**City of
Richmond**

Report to Development Permit Panel

File: DP 20-899883

Re: **Application by Orion Construction for a Development Permit at 3640 No. 4 Road**

LANDSCAPE PLAN,
PLANTING PLAN

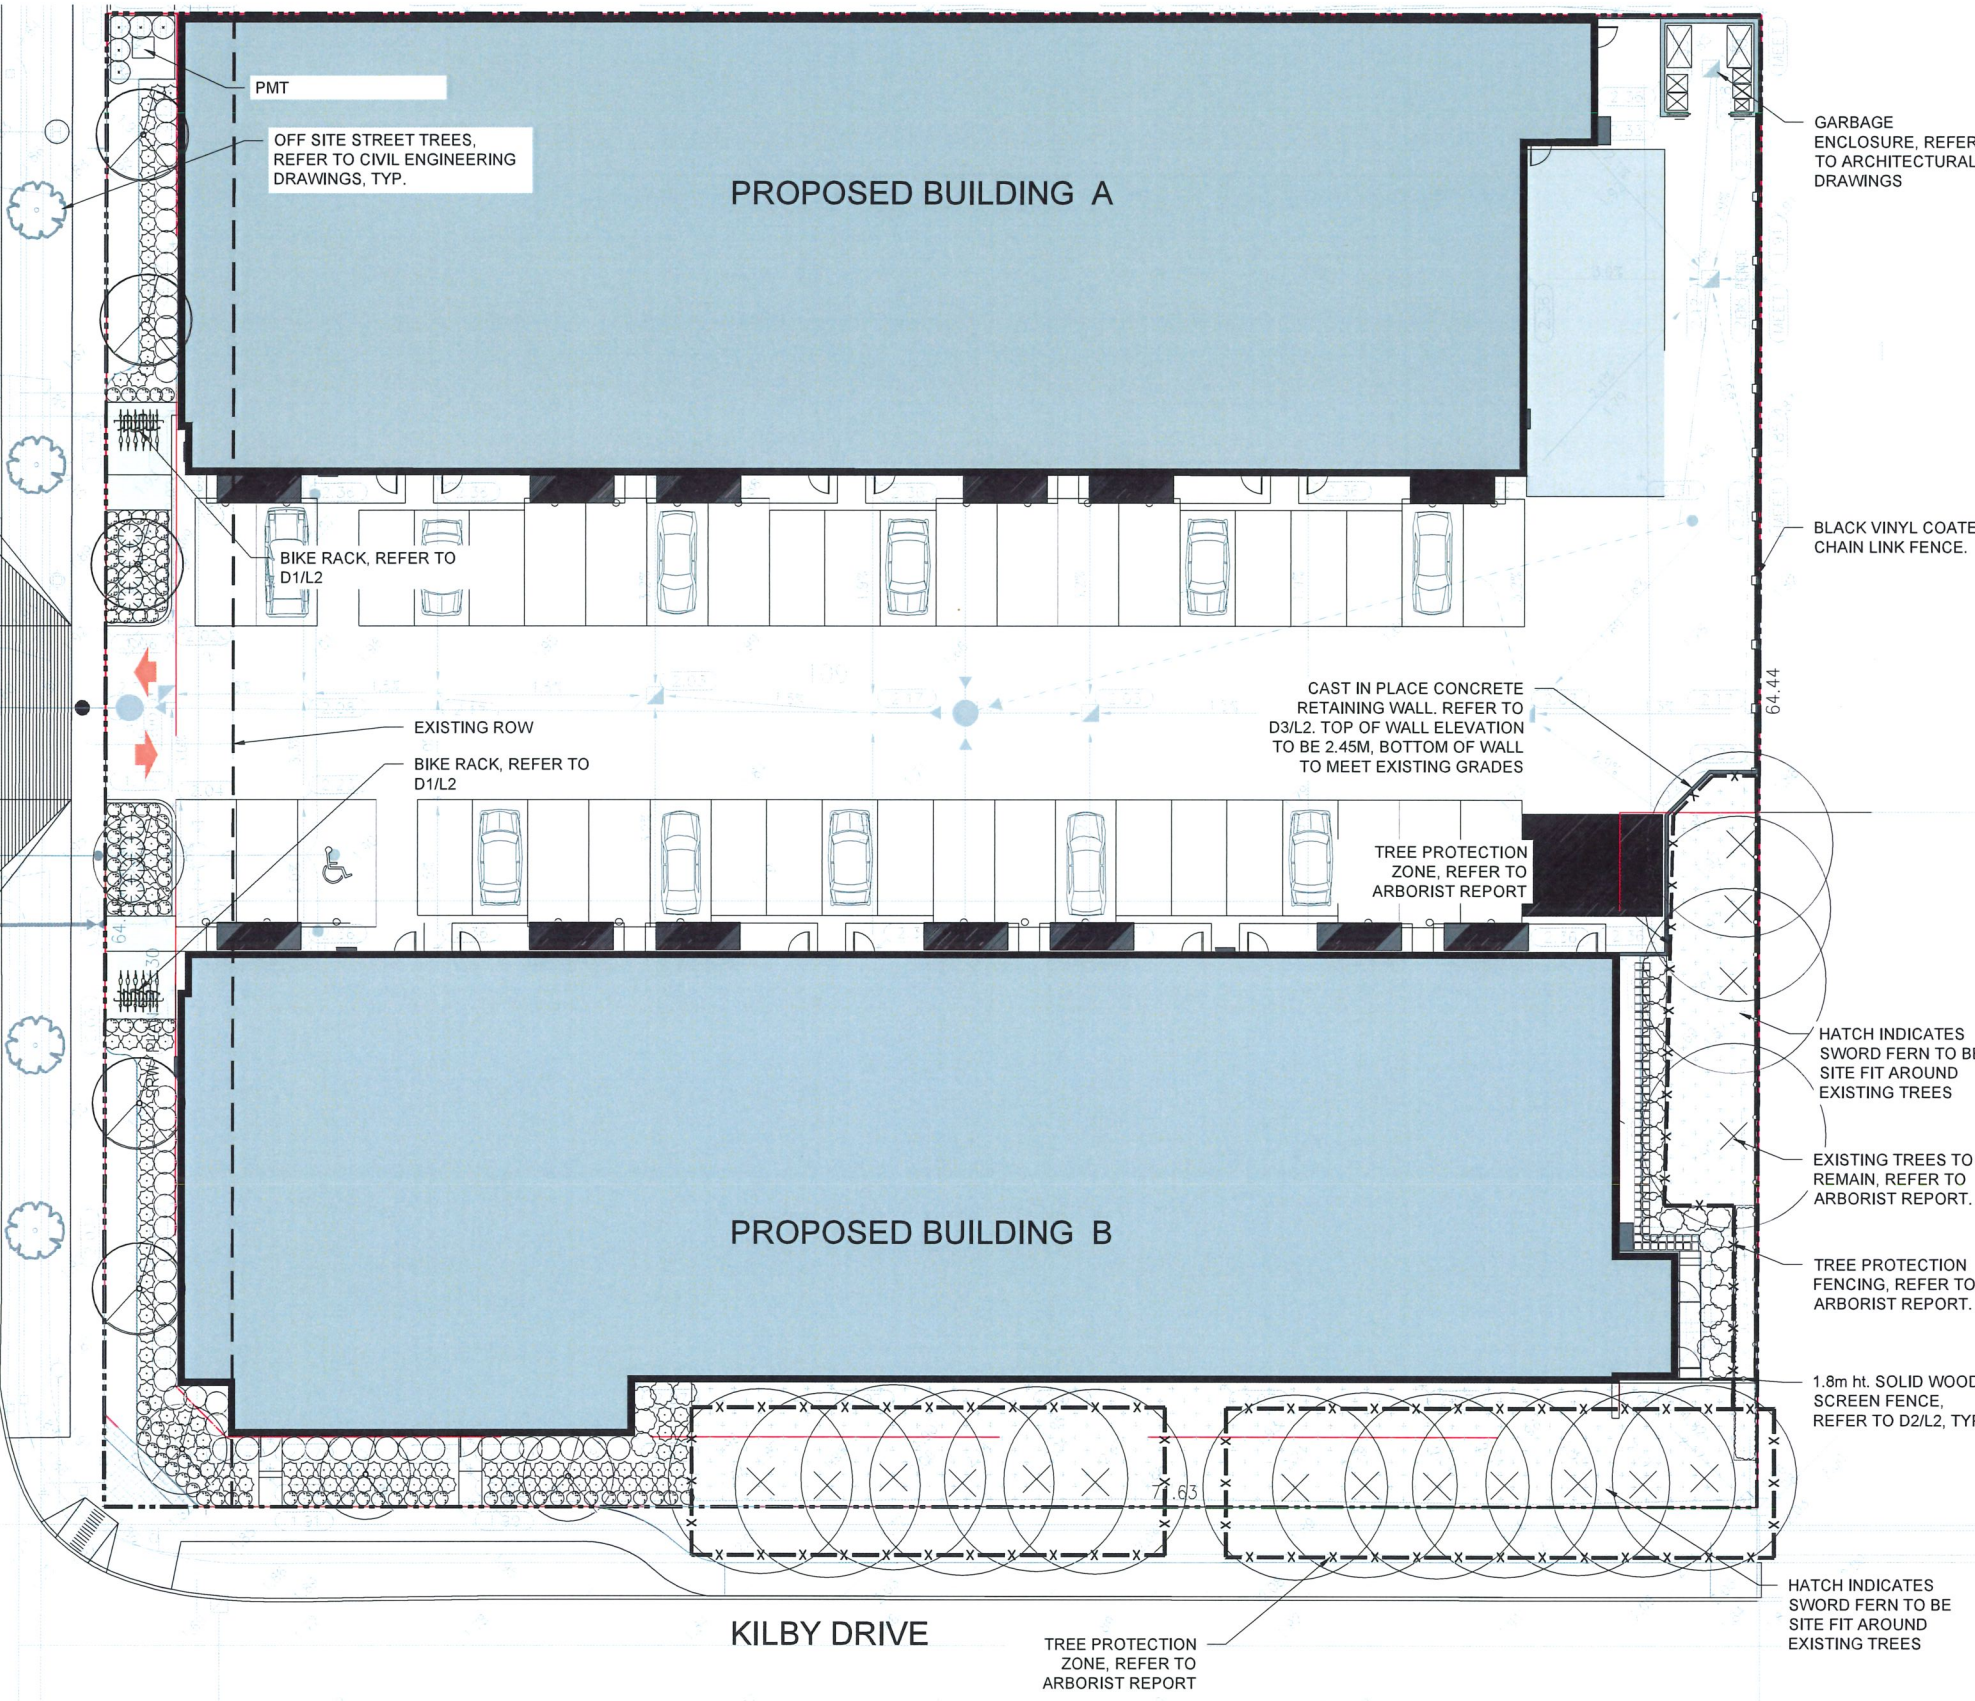
- consider installing full landscape beds along the south frontage as shrub planting can better protect the trees;

Additional landscaping has been included on the south frontage as suggested. Refer Landscape Plan.

ELEVATIONS

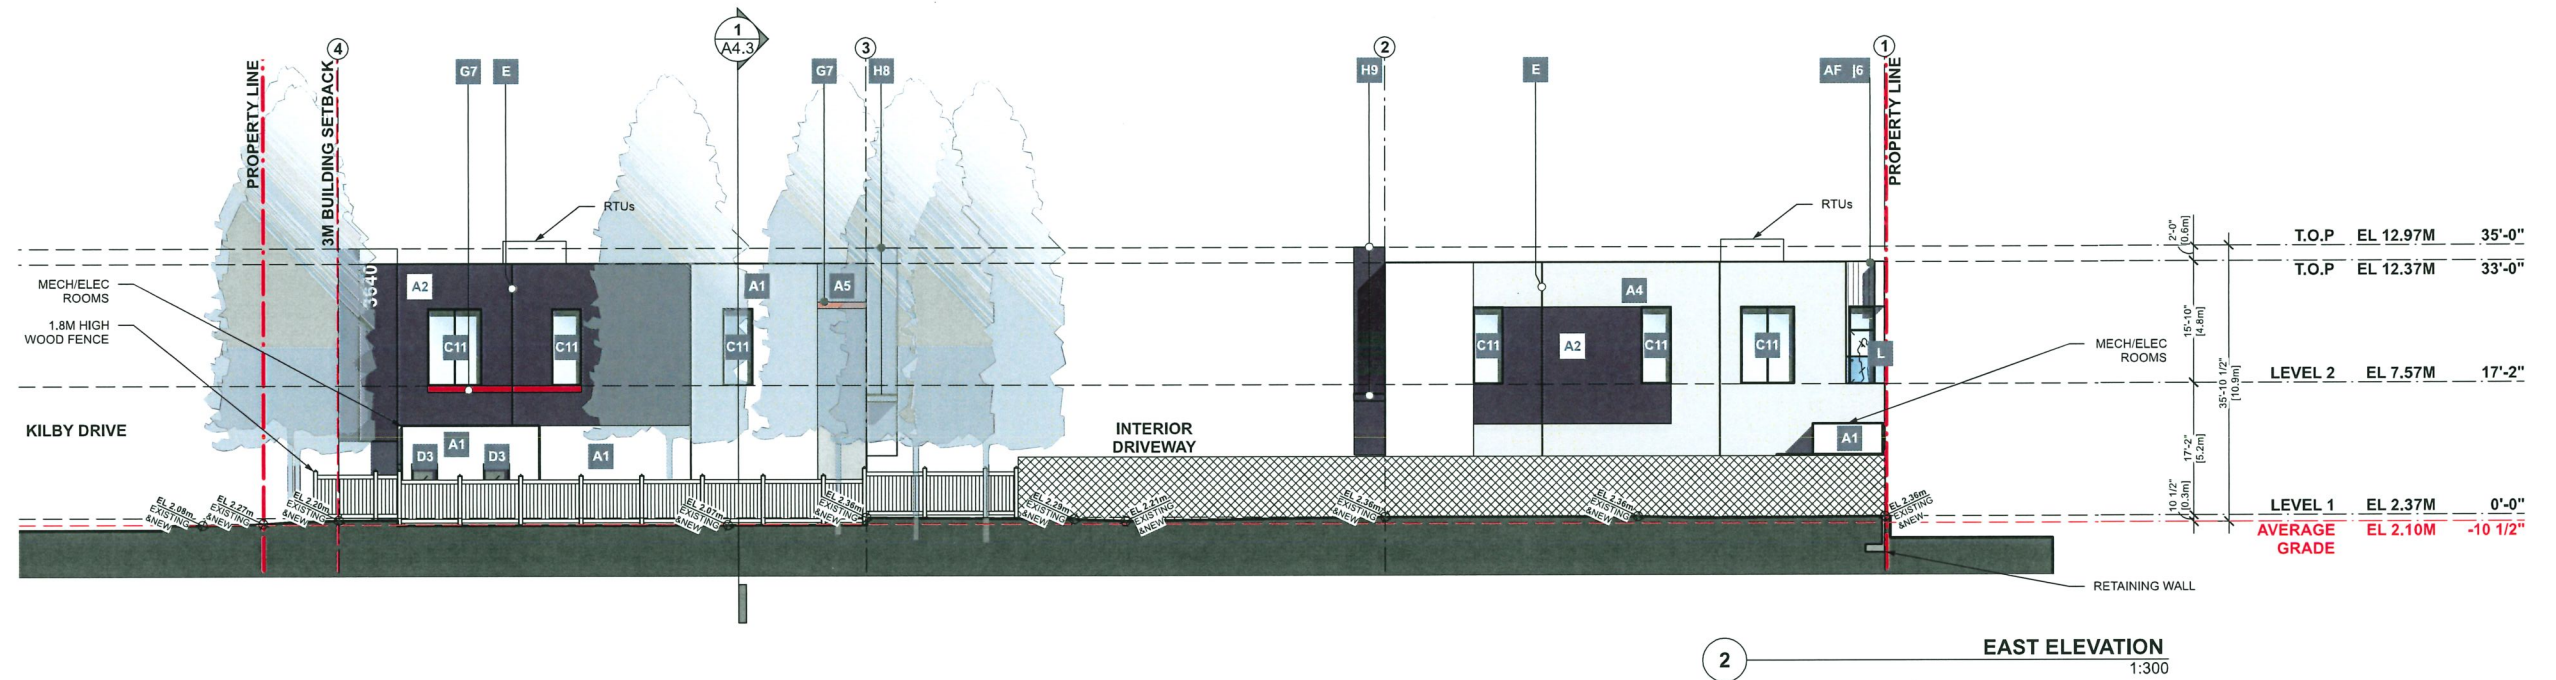
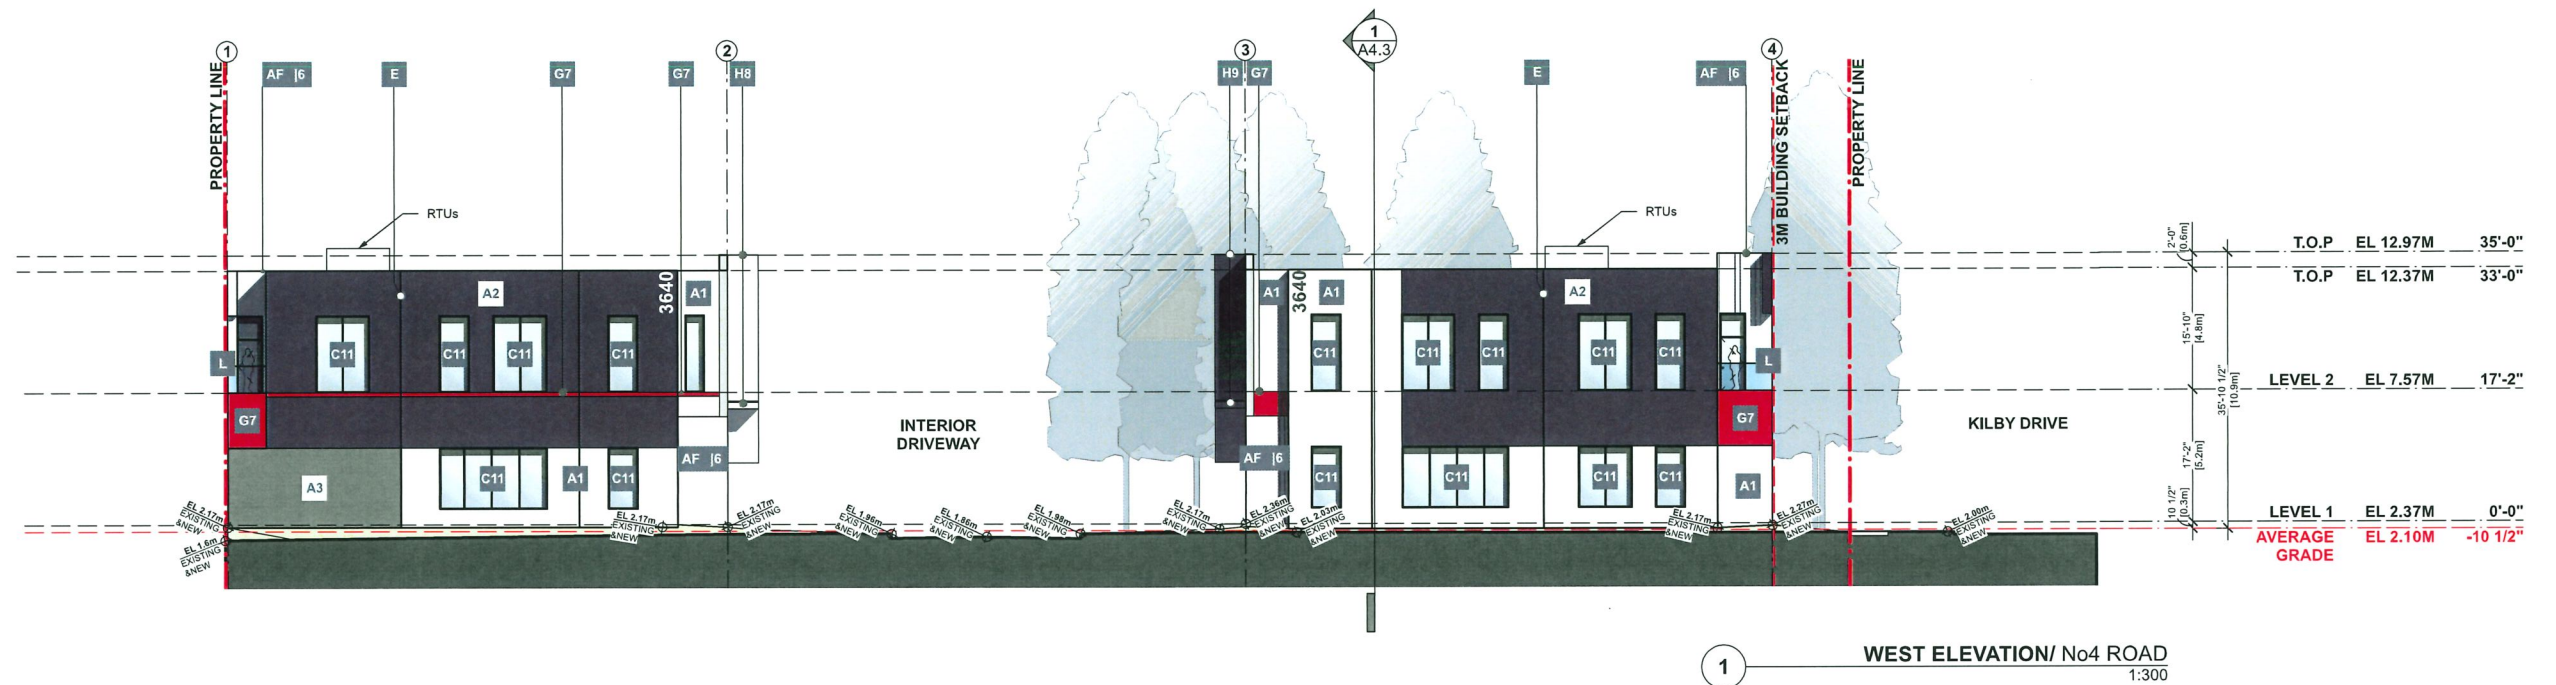
- concerned about the design of the north building's (Building A's) north elevation, i.e., its openings, colour treatment, finishes and balconies should the future development on the neighbouring property to the north include no setback; the applicant needs to review the design of the north façade to provide an appropriate interface with the future development to the north;

- colour-blocking appears a bit random at moments, e.g. red stripes on the east and west elevation don't go far enough; consider opportunities where there are changes in plane to fill in the colours, e.g. red infill on the west façade in locations near the balcony;

The potential of a mural on the north elevation of Building A has been explored with the City's Public Art department. A number of potential options were discussed and, in a balanced and reasonable approach to improve the interface of the north wall to the public realm, it is proposed to continue the project's paint colour theme, adding a band of ruby red, black and gray as well as an architectural form liner to the panels themselves. (Refer Elevations A4.1). Additionally, as part of the City's development cost charges, the project will contribute approximately \$10,000 to the City's public art fund.

It is acknowledged that there is a potential for the site to the north to redevelop to a zero lot setback however given the considerable area of that site (229,701 sq ft) there are considerable design options available. The benefits to the building design and future occupants of this project by providing the balconies outweighs the potential future impacts.

The south elevation of Building B will be hidden from view of the street by the existing vegetation (which will be retained). In addition, the parapet height at the southwest corner has been increased to enhance and create additional articulation along this elevation. (Refer revised elevations).
